**CASE NO. 8905**

# REPORT

Review of the engineering hydraulics submitted by

Wood Creek Water District in Case No. 8905.

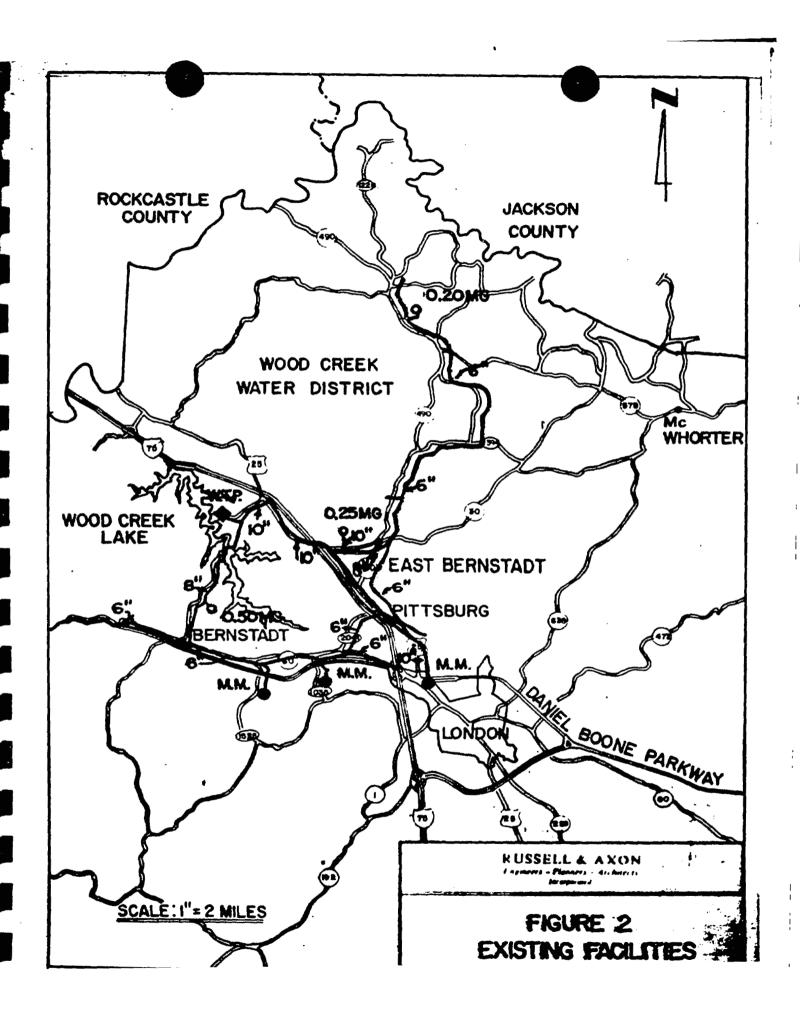
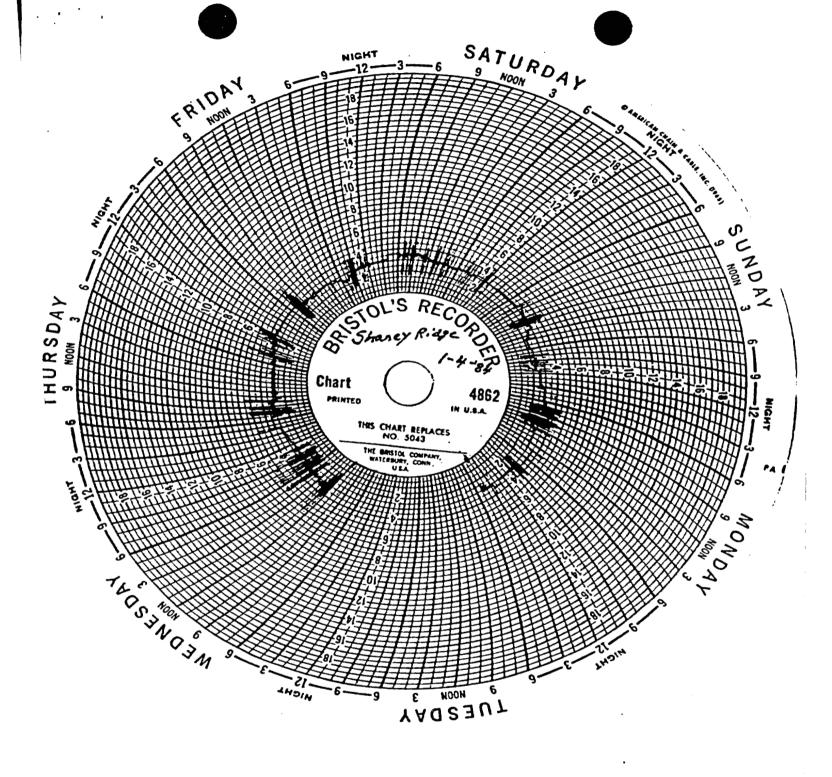
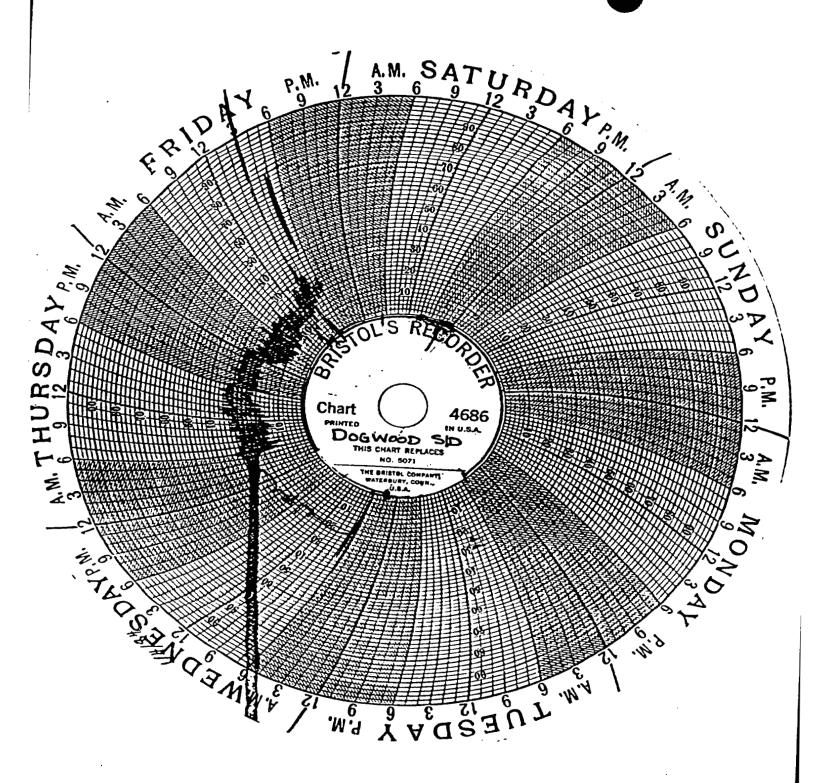
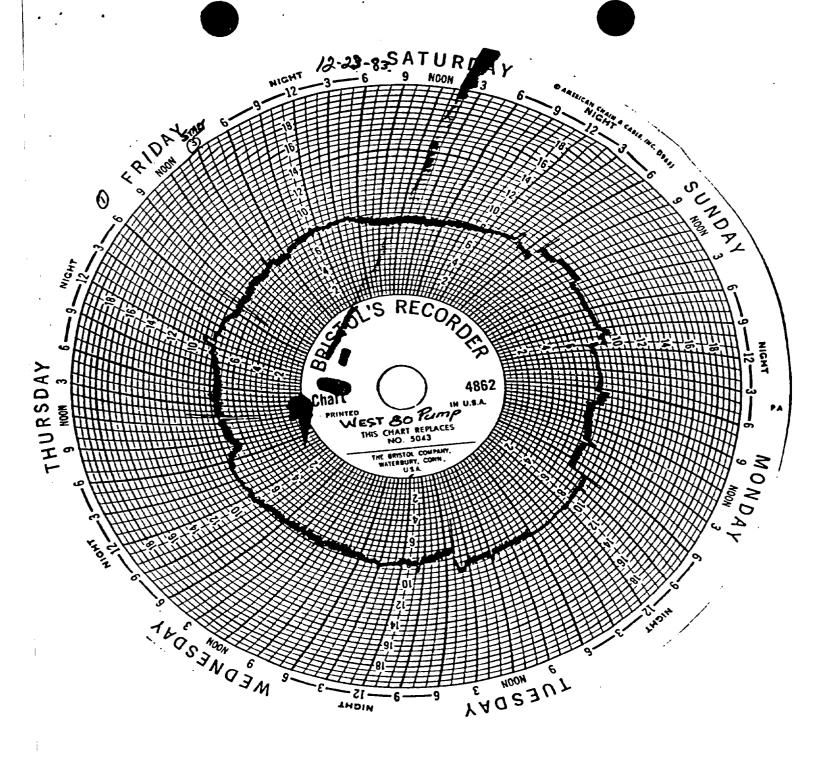
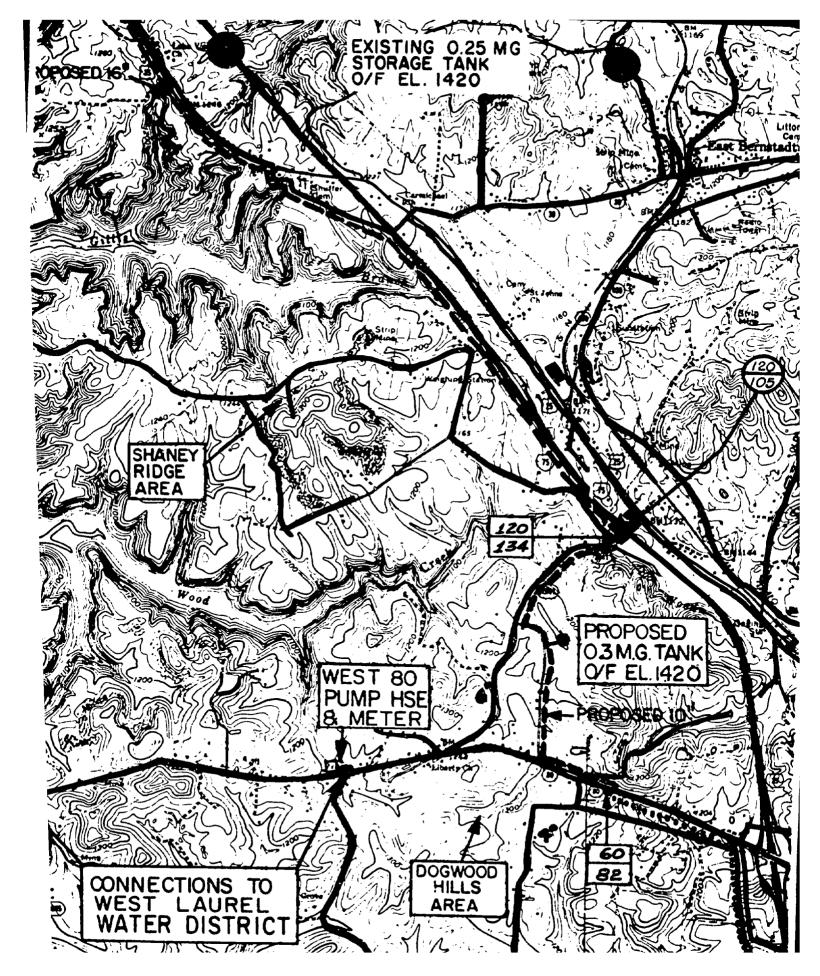
The only evidence of the hydraulic gradient available in the vicinity of the proposed standpipe are the pressure recorder charts Wood Creek provided for Shaney Ridge, Dogwood Subdivision, and the West 80 pump station. Examination of the Shaney Ridge chart shows a recorded pressure in the range of 30-35 PSI with several noticeable sharp "spikes" of higher and lower pressures. These pressures mean a hydraulic gradient of 1,369 feet ASL to 1.381 feet ASL. This appears to be particularly the case in the daily time period from midnight to 6:00 A.M. when customer usage would be expected to be a minimum. The chart labled Dogwood Subdivision shows fairly constant activity at all hours of the The pressures are mainly between 10 PSI to 30 PSI for the period recorded. This translates to a hydraulic gradient from 1,323 feet ASL to 1,369 feet ASL with no observeable slack period. The chart for the recorder at the West 80 pump station plots a reasonably steady pressure varying between 70 PSI and 90 PSI. This equates to a hydraulic gradient of 1,352 feet ASL to 1,390 feet ASL. In addition, there is a distinct pressure increase lasting approximately an hour recorded on two occasions in the early morning hours between midnight and 6:00 A.M. These abrupt pressure changes suggest some sort of pump activity on the distribution system, possibly the West 80 pump station itself. During these two short periods the hydraulic gradient is around 1,402 feet ASL. All of this suggests that the existing water distribution system cannot support a water level in the proposed standpipe above 1,380 feet ASL - or less than two thirds full.

Wood Creek's flow rate charts show that the District routinely ran the treatment plant's high service pumps around the clock to meet its customer demands. During the period represented by the flow rate charts the high service pumps were only occasionally turned off. Hand written notations on the charts indicate that at no time was Wood Creek able to fill both the Mt. Moriah and "Mother" tanks. The charts do show a few instances when the "Mother" tank got within 3 or 4 feet of full.
